UNITED STATES PATENT AND TRADEMARK OFFICE

APPLICATION NO.	FILING DATE	FIRST NAMED INVENTOR	ATTORNEY DOCKET NO.	CONFIRMATION NO.
10/674,198	09/29/2003	James Patrick Clinch	140/40652/O&T 975	2676

Office Action Summary	Application No. 10/674,198	Applicant(s) CLINCH ET AL.	
	Examiner Katherine W. Mitchell	Art Unit 3677

DETAILED ACTION

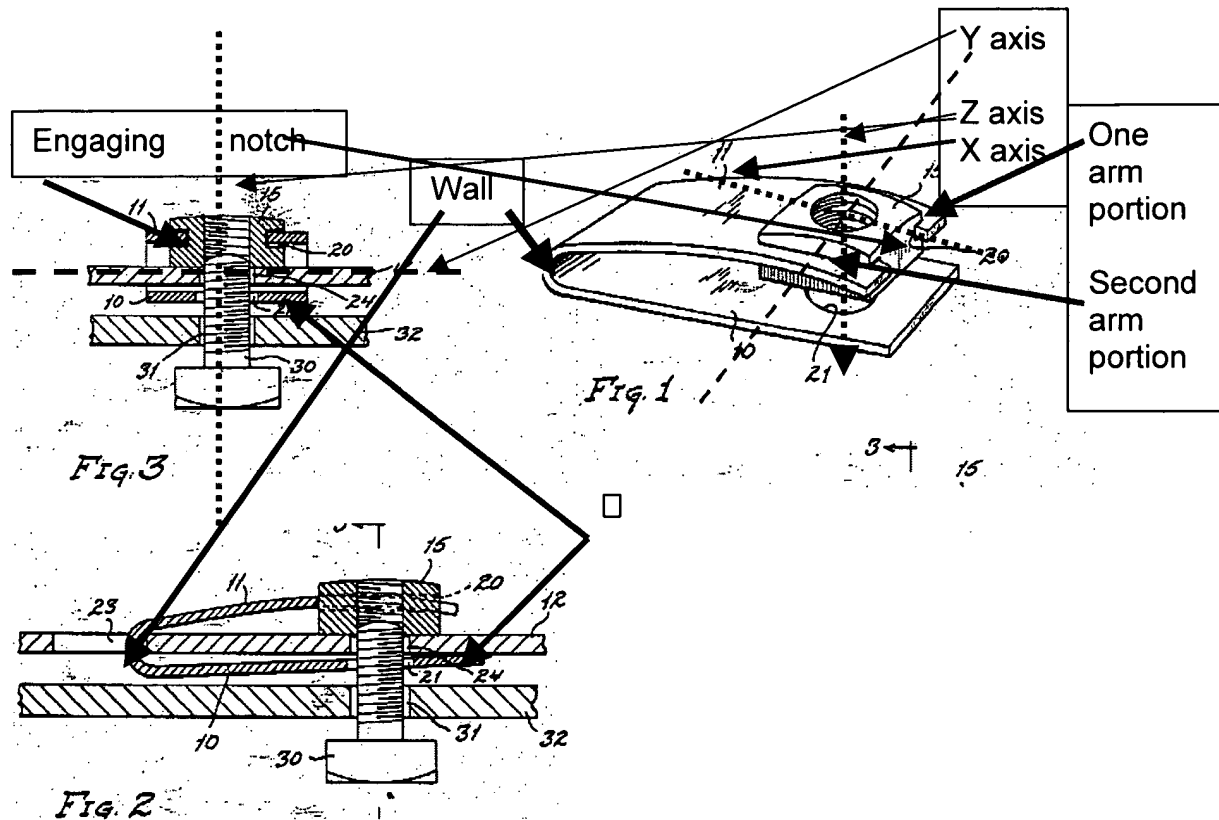
Re claims 1-3, 5-7, 10,11,12,19, 29, 30, 32-35, 37-42, 51-54 and 57-58:
Tinnerman 342 in Figs 1-3 teaches a cage member and nut assembly, said nut (15) having a 1st and 2nd portion (see marked up drawings below) enclosed by a cage member (10/11) which has a body configured to engage the nut member such that the nut member is encaged. The cage further comprises a body (11/10), and "11" is considered the upper cage/arm portion, and "10" is the base. The wall is labeled by examiner in drawings below. The nut engagement is such that the 2nd portion (same as the portion labeled "1st plate" below - looking at the drawings as oriented, it is the "lower" part of nut below "11") of the nut does not come into contact with either the base or the wall. Figs 1 and 3 shows a limited range of motion in three dimensions, and thus in two dimensions, wherein neither of said two dimensions is provided along n axis about which the nut aperture is defined. The body provides a limited range of nut movement in at least two dimensions (axially along what could be called the bolt axis or z-axis is one dimension of limited movement, the plane perpendicular to this, in the x-axis approximately on the surface of "11" -- see dotted lines added to figure 1 below).

Further Re claims 3 and 12: As shown in Fig 1, arm portion 11 forms two arm portions at the end as labeled by examiner in drawings below. These two arms are opposite each other.

Further Re claims 29-30 and 34-35 and 39-42: Tinnerman '342 in Figs. 1-3 teaches a nut (15) enclosed by a cage member (10/11) which has a body configured to engage the nut member such that the nut member is engaged. (Fig 1 and 2) "11" is considered the upper cage portion, and engaging notch (best shown in Fig 1 and 3) will inherently serve to suspend the nut off the base.

Fig 1 and 3 show said nut with 1st plate and 2nd plate and a connecting member between said plates, each plate having an upper and lower surface, with aperture therethrough. The upper portion of cage comprises at least one arm extending from said base with said arm having an upper surface in contact with said lower surface of nut second plate (see marked up figures)

Further Re claims 29-30, 34,35: Fig 1 shows a cage member suspending the nut off the base, and above the base, prior to said fastener being received in the nut aperture.

Further Re claim 32,37: The body further comprises at least one wall (see label by examiner above), and Figs 1- 3 show the nut engaged such that the nut does not contact at least one wall.

Further Re claims 33,38: Said body comprises at least one arm 11 which serves to suspend said nut above said base. (Figs 1 and 3). Examiner notes that applicant did not require the arm to extend **directly** from said base - it extends from the wall which extends from the base, and thus is also considered to extend from the base.

Re claims 52,54: at least part of the arm portions (marked up Fig 1) are capable of independent movement relative to each other -pliers on the end of each arm could move them independently.
